CITY OF ALBUQUERQUE

RE: **Lot 7 Block 7 Unit 2 SAD 227**
7911 Kibo NW
Grading and Drainage Plan
Engineers Stamp Date 3/28/19 (E10D060)
Pad Certification Date 4/16/19

DRAINAGE AND TRANSPORTATION INFORMATION SHEET (REV 6/2018)

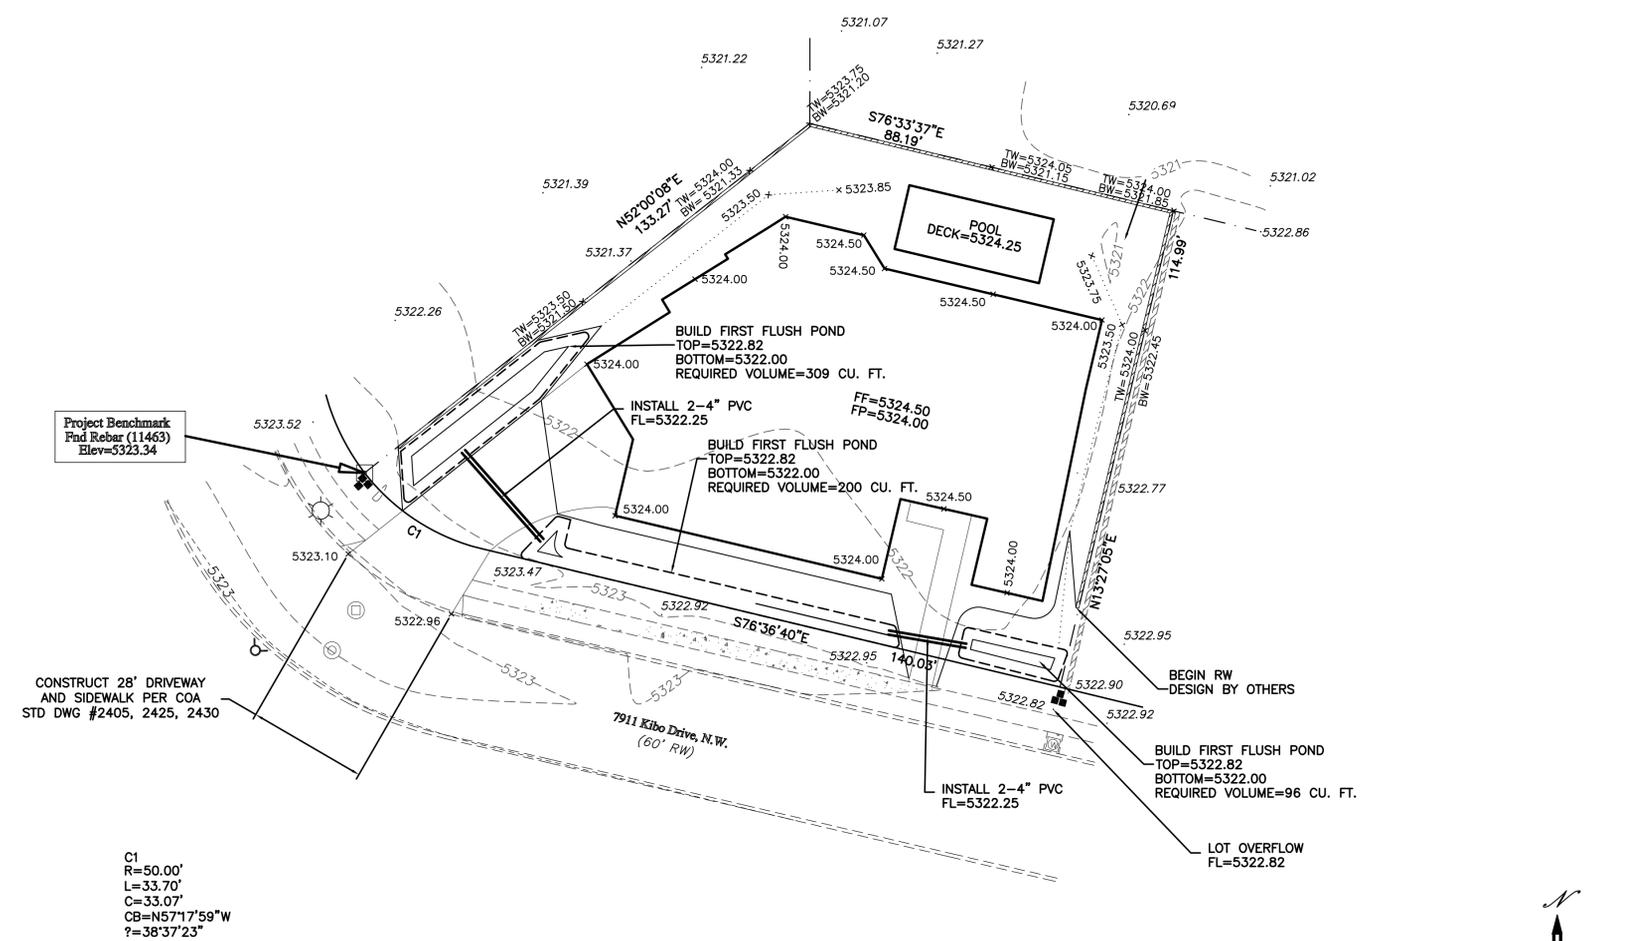
Based upon the information provided in your submittal received 4/23/19, this plan is approved for Building Permit.

Reiterate to the Owner/Contractor that a separate permit for a garden/retaining wall must be obtained, with the approved G&D plan dated 4/16/19.

Prior to Certificate of Occupancy release, Engineer Certification per the DPM checklist of this plan will be required.
